STATE OF CALIFORNIA  
Department of General Services - Office of Procurement  
**PURCHASE ORDER**

Purchase Order No. Rev. Date  
**62153** 6/30/2008

PURCHASE ORDER CHANGE #1  
MARCH 10, 2009

Purchase Order Change (POC) #1, for Antenna Trailer Equipment has been modified to reflect the following changes.

**SPECIAL CABLE HANGER  
ASSEMBLY DETAILS**

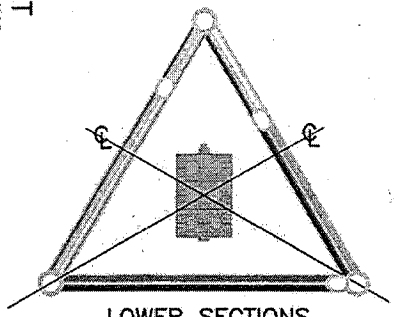
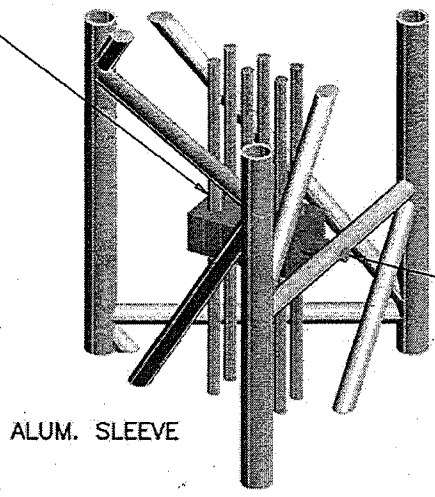
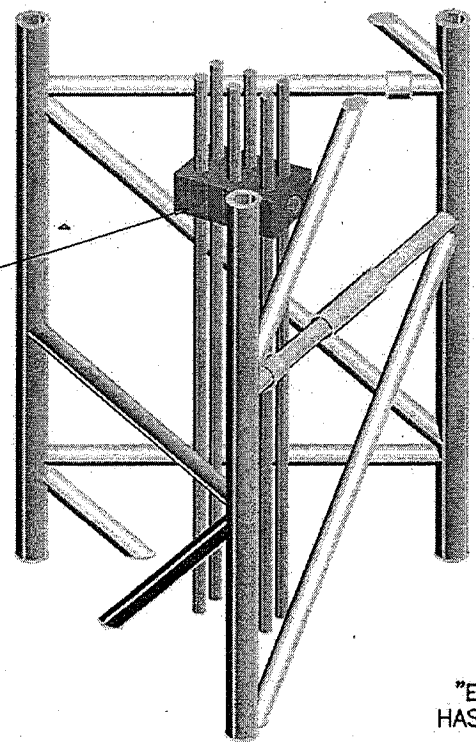
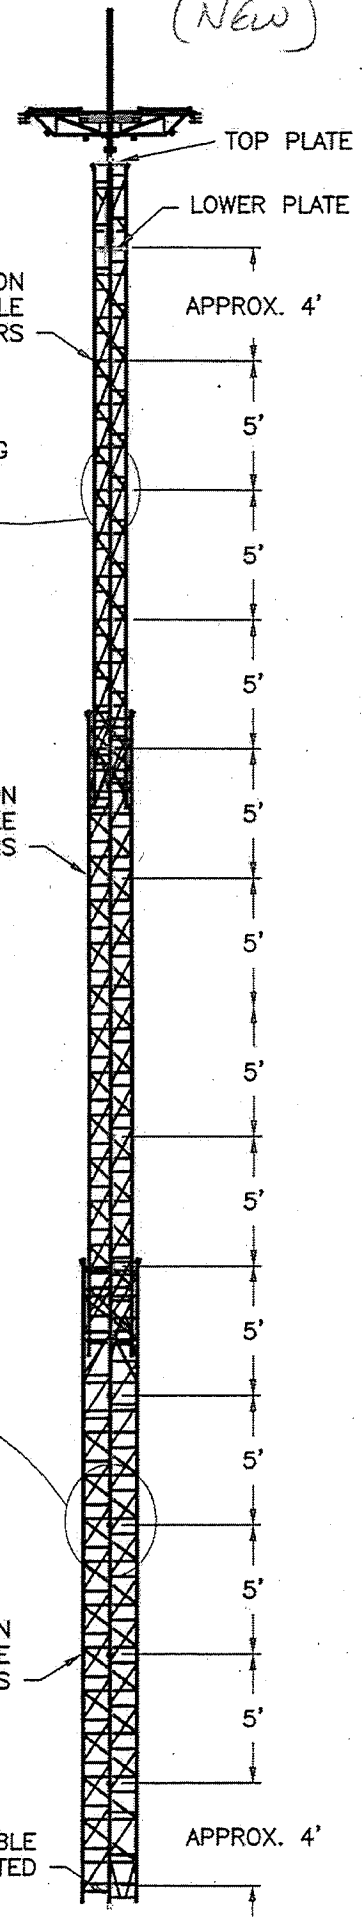
- 1. Delivery Date Change**  
The 180 days After Receipt of Order (ARO) date of March 14, 2009 has been extended to April 1, 2009.
- 2. Change in Specification & substitution of drawings**  
Substitute the attached drawings for Specification 3.2.2 page 8 of 11, Specification 3.2.3 page 9 of 11, and Specification 3.2.4 page 10 of 11.
- 3. Delete specification requirement no. 3.3.2 (page 3 of 11).**
- 4. Model Change**  
Specification requirement 3.5.27 (page 6 of 11) from 4-1000W/240VAC to four (4) FRC Optimum Quartz halogen lampheads, 50 4-500 watt bulbs for a total output of 2000 watts. Height of the light per the bid specification would change from 6ft to 7 1/2 ft.  
Model: NS 1.8 3000-4 OPT 240 VAC
- 5. Other specifications clarification and/or modifications on attached revision recap document is being provided for reference and have been incorporated into the purchase order award.**

- 3.2.4 Need to discuss alternatives to Annex C proposal due to weight issues of pipe and hindering telescoping of tower. Need clarification of intending cable routing and storage. Aluma has some ideas to propose.

**ALUMA PROPOSES A PROTECTIVE BRAIDED SHEATHING DESIGNED FOR SUCH APPLICATIONS. PLEASE REVIEW AND PROVIDE APPROVAL.**

REV.	DATE	DESCRIPTION	BY
B			
A	2-6-09	ADDED TOP VIEW SHOWING HANGERS CENTERED	H.C.

## ALUMA DRAWING AT-1885 REPLACES ANNEX C AND HAS BEEN APPROVED

**3-D DRAWING OF SPECIAL 4 WAY  
STANDOFF WITH CENTER MAST**

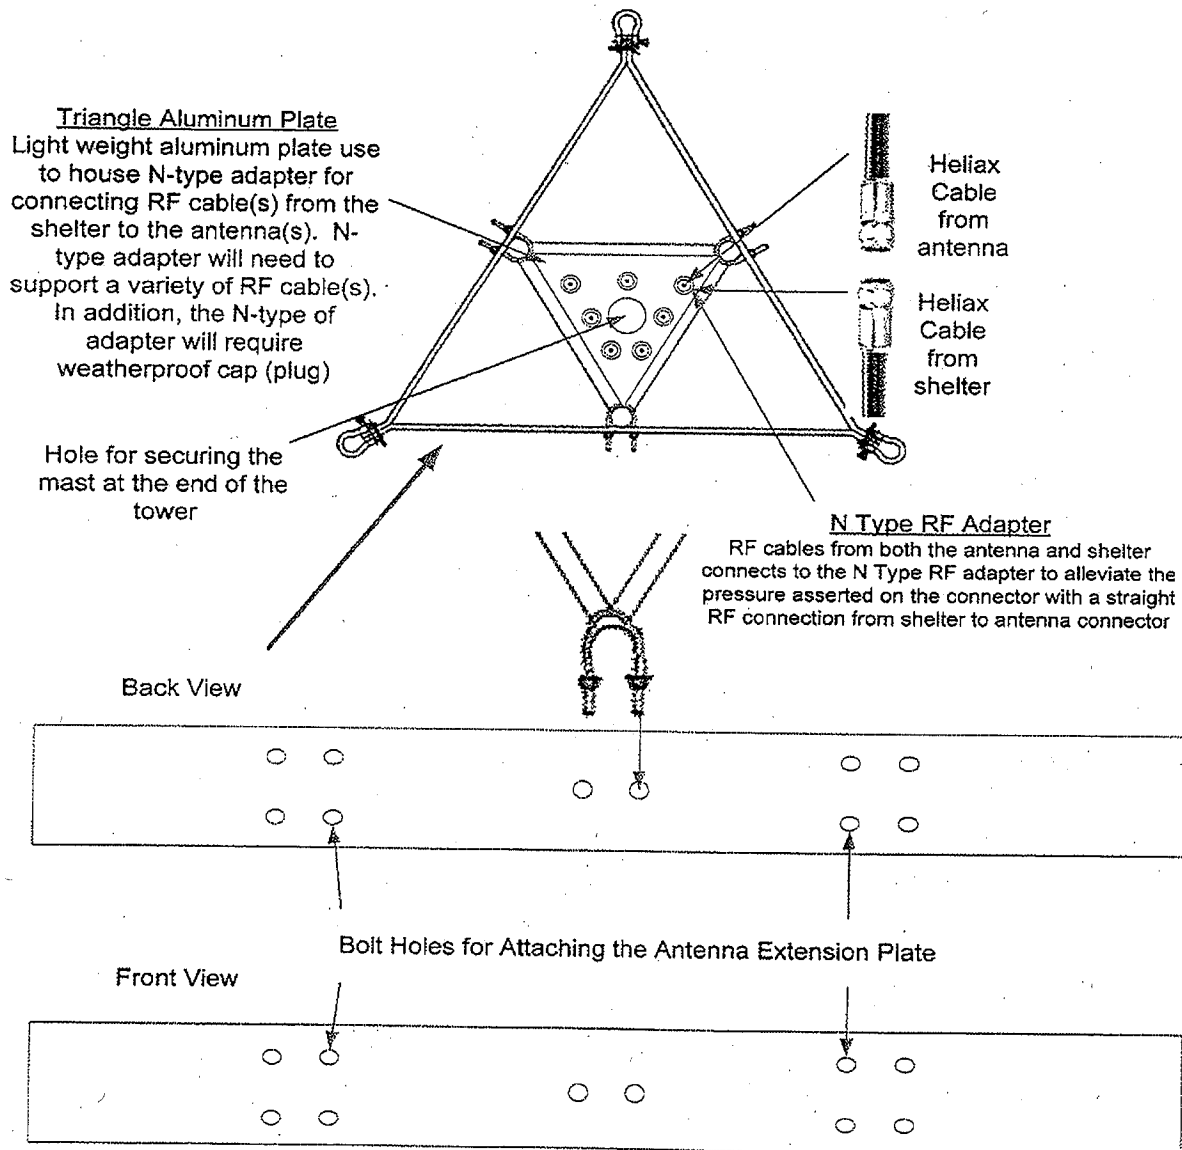
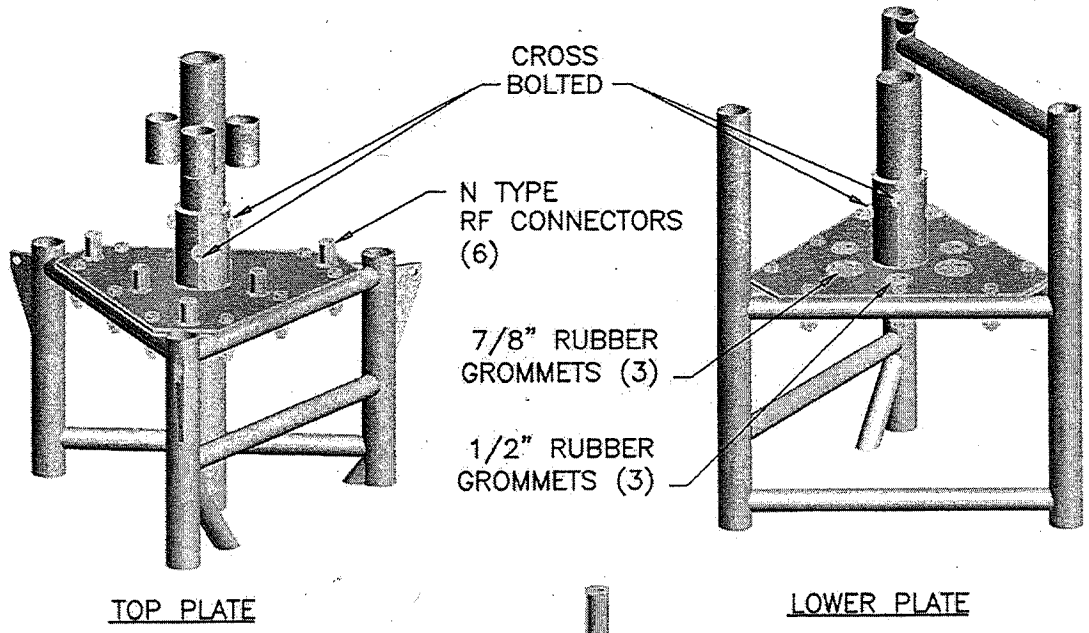
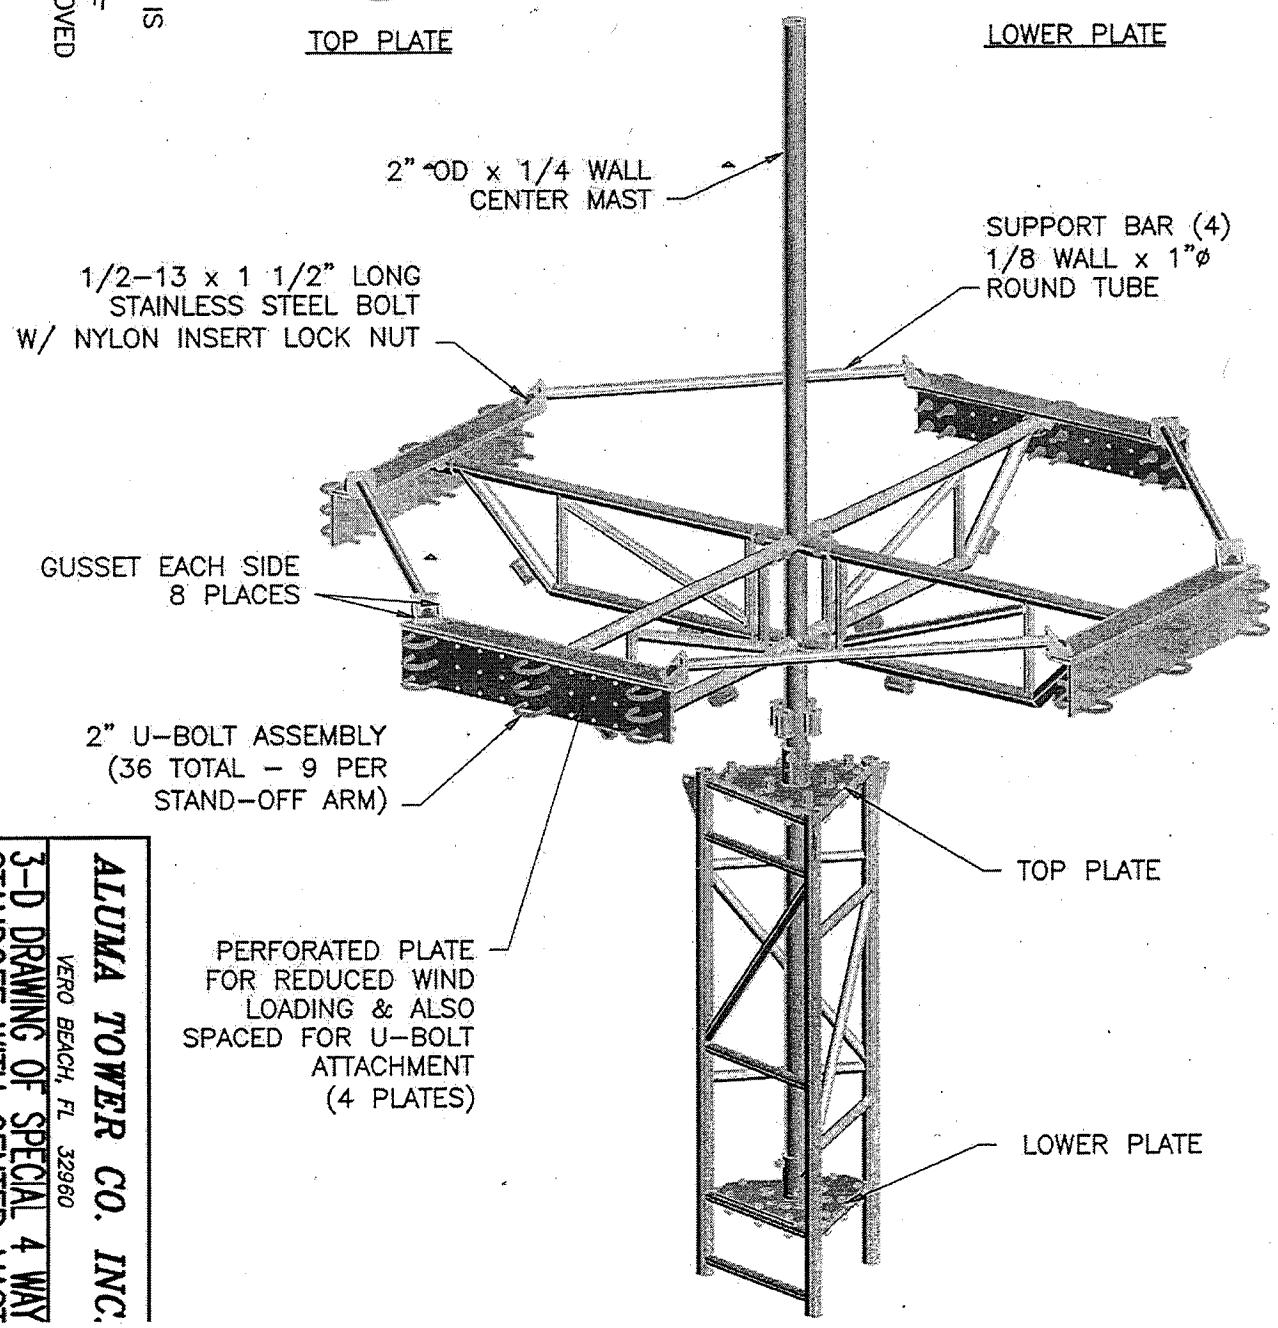
- 3.2.3 Previously discussed using Aluma Torque brackets atop each section to mount cable adapter plates to replace Annex B cable adapter plates.

**Aluma to design something similar to existing coax cable standoff product. Aluma to provide drawing for final approval.**

REV.	DATE	DESCRIPTION	BY
B	2-6-09	ADDED HOLES TO U-BOLT BRKT., GUSSETS TO EACH SUPPORT BAR ANGLE, (3) 7/8 GROMMETS	H.C.
A	2-3-09	ADDED TOP & LOWER PLATE DETAIL VIEWS	H.C.

## ALUMA DRAWING QS-1835-2 REPLACES ANNEX B AND HAS BEEN APPROVED
